RE: Lake View Geothermal Project (Unit 17) (79-AFC-01C): Petition for Modification—Fire System Recommissioning Activities

**Petition for Modification
Fire System Recommissioning Activities**

LAKE VIEW GEOTHERMAL POWER PLANT (“UNIT 17”)

PETITION FOR MODIFICATION

Figure 2
Flow Diagram Showing Emergency Standby Wet Down Pump Diesel Drive Engine
Perkins Model 1206F-E70TTA

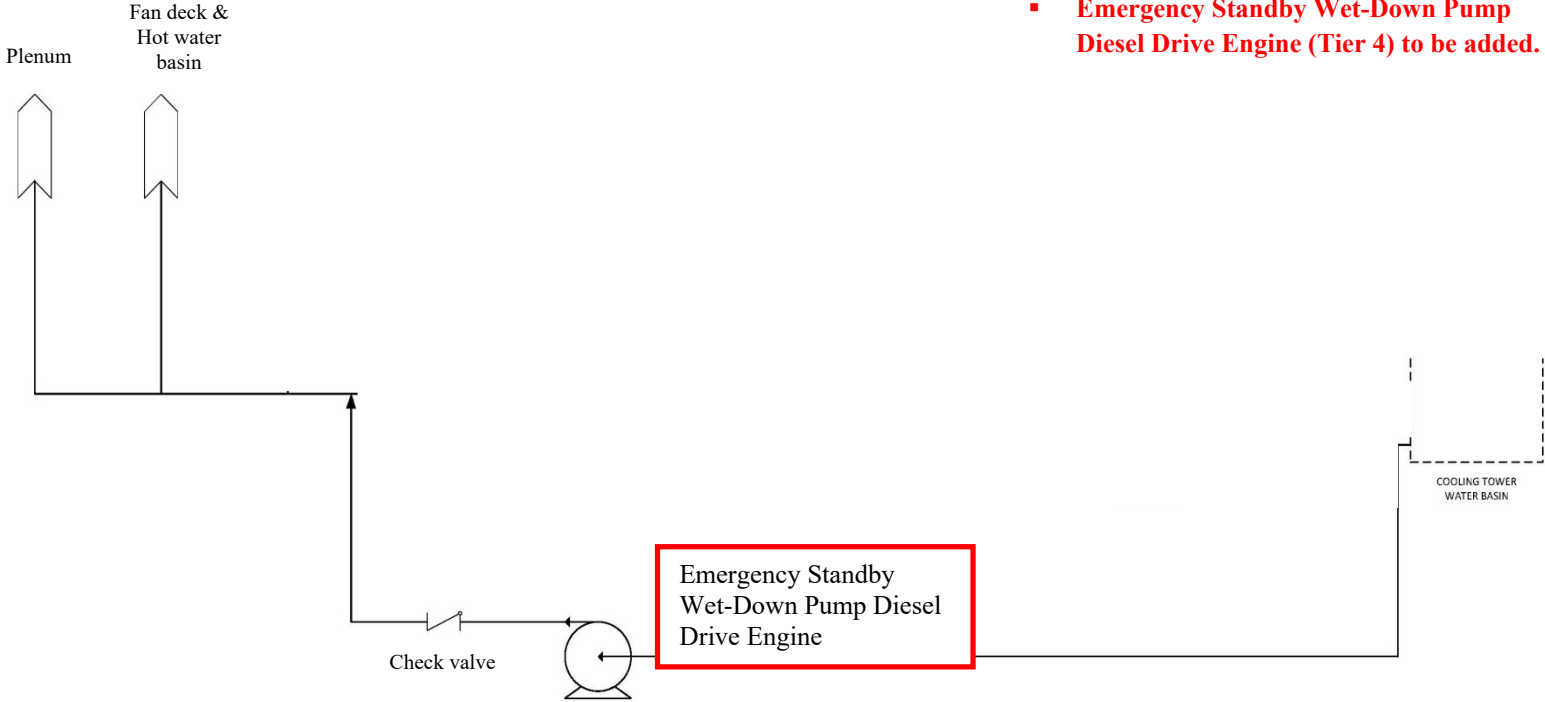
A permanent emergency standby wet down pump diesel drive engine is proposed to be added for use in the event of a plant evacuation due to the threat of an approaching wild land fire. The location of the emergency standby wet down pump diesel drive engine is shown adjacent to the cooling tower circulating water pit on the Lake View Power Plant Plot Plan (**Figure 3**).

Note:
▪ **Emergency Standby Wet-Down Pump Diesel Drive Engine (Tier 4) to be added.**
